Dealer Product Campaign Bulletin

NUMBER: 77-C-13

SUBJECT: ONAN GENERATOR POSSIBLE 110V AC CONDUIT INTERFERENCE WITH POSITIVE BATTERY STUD

MODELS: 1976-1977 MOTORHOMES EQUIPPED WITH RPO KNC
(Onan 6.0 KW Generator)

Figure 1

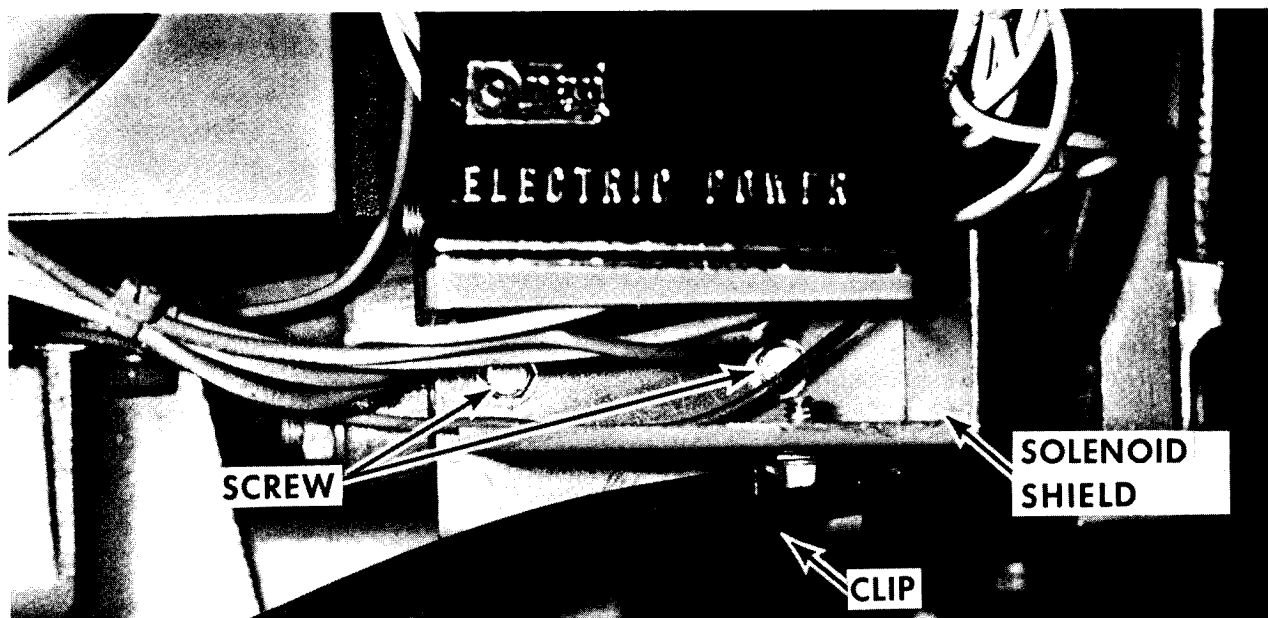
The 110 Volt AC conduit on these Onan generators may contact the positive battery terminal or starter solenoid post resulting in a short to ground of battery power. Also the 110 Volt AC conduit and cable insulation may wear through from contact with the negative battery terminal causing a short to ground of 110 Volt AC power. Such shorting will damage wiring and generator components and can result in a fire. A fire may result from shorting of the battery power to ground even if the Onan generator is not operating. The fire may burn the fuel supply hose to the generator unit resulting in a gasoline fed fire. Fires originating at the Onan generator could spread to the passenger compartment and cause burn injuries and asphyxiation of occupants.

3. Disconnect ground cable at living area battery.
4. Remove two screws located under the control board. (Refer to Figure 1).
5. Position solenoid shield as shown in Figure 2, and install retaining screws. The control panel ground wire must be properly secured at this time. Secure starter cable with clip as shown in Figure 1.
